Federal Recall Information

19PBF

PACCAR

Certain Model 520 vehicles with Right-Hand Standup (RHSU) configuration may have improperly supported steering assist bracket.

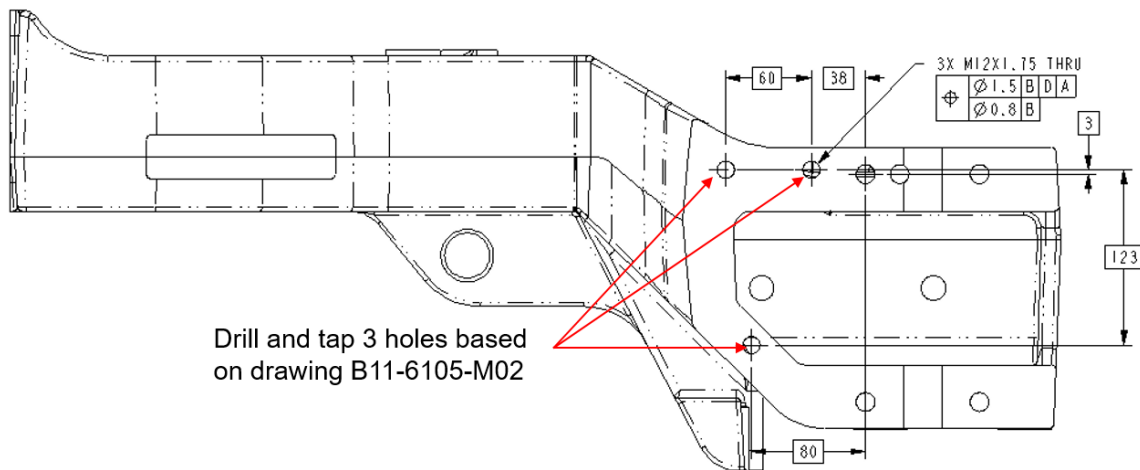
Peterbilt Motors Company has decided a defect, which relates to motor vehicle safety, may exist in certain Model 520 vehicles with Right Hand Stand Up (RHSU) configuration built between June 15, 2018 and February 14, 2019. Vehicles may have an improperly supported steering assist bracket due to the incorrect spring bracket installed. The spring bracket may be missing 3 drilled and tapped holes which will provide additional support for the steering gear assist bracket.

An improperly supported steering gear assist cylinder bracket may break and cause damage to surrounding components and/or lock up the steering, increasing the risk of a crash.

1. Inspect the steering gear assist bracket to ensure it is mounted with all 5 bolts. If all 5 bolts are installed. No further action is required.
2. Replace the steering gear bracket, drill and tap 3 holes per drawing B11-6105-M02R and mount the new steering gear assist bracket to the spring bracket with 5 new bolts and washers. See image below.

1. Drill – 10.3mm or 13/32 drill
2. Tap – M12 X 1.75
